# Access Compliance Report

## Public Rights-of-Way

Intersection ID: 2977	Main Street: ELDESLIE_DR	Cross Street: HARBURN_FOREST_DR	Location: SW
ADA ID: 1571B8449B86	Ramp Type: PerpDiag	Initial Pass/Fail: Fail	Overall Compliance: No
Severity Score: 25			
Codes/Mitigation Info/Possible Solution		Field Measurements/Component Compliance

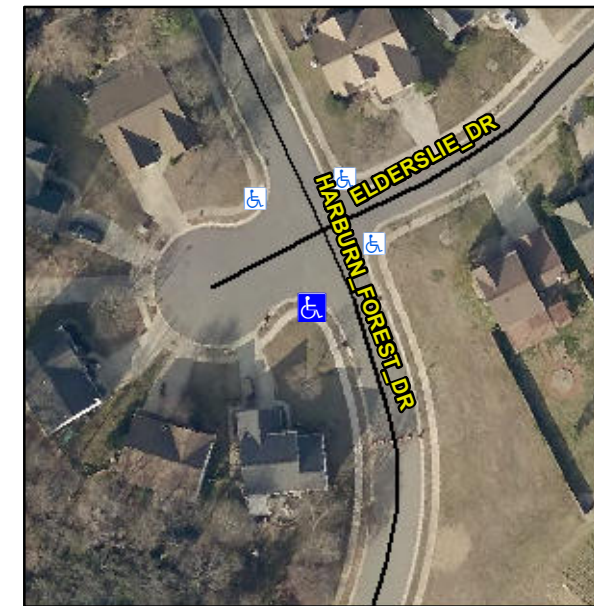
**Not Found, R304.2.2**

Compliance	Description	Data	Compliance	Description	Data
N/A	Ramp Length (in)	48.0	No	Ramp Slope (%)	14.3
Yes	Ramp Width (in)	48.0	Yes	Ramp XSlope (%)	1.5
N/A	Flare Type LT	N/A	N/A	Flare Type RT	N/A
N/A	Flare Slope LT (%)	N/A	N/A	Flare Slope RT (%)	N/A
N/A	Flare Traversable LT?	N/A	N/A	Flare Traversable RT?	N/A
N/A	Landing Length (in)	N/A	N/A	DWS Provided?	N/A
N/A	Landing Width (in)	N/A	N/A	DWS Contrast?	N/A
N/A	Landing Slope (%)	N/A	N/A	DWS Length (in)	N/A
N/A	Landing X Slope (%)	N/A	N/A	DWS Full Width?	N/A
N/A	Landing Curb? (Y/N)	N/A	N/A	DWS Offset (in)	N/A
N/A	Shared Landing?	N/A			
N/A	Gutter Ponding?	Yes	N/A	Gutter Slope (%)	N/A
N/A	Gutter Lip Ht (in)	N/A	N/A	Gutter X Slope (%)	N/A
N/A	Painted X Walk1?	No	N/A	Painted X Walk2?	No
	X Walk 1 Direction	To E		X Walk 2 Direction	To N
N/A	X Walk 1 Width (in)	N/A	N/A	X Walk 2 Width (in)	N/A
	X Walk 1 Slope (%)	2.4		X Walk 2 Slope (%)	1.0
	X Walk 1 X Slope (%)	1.4		X Walk 2 X Slope (%)	1.4

**Remove & Replace Curb Ramp With Two New Directional Ramps or Equivalent.**
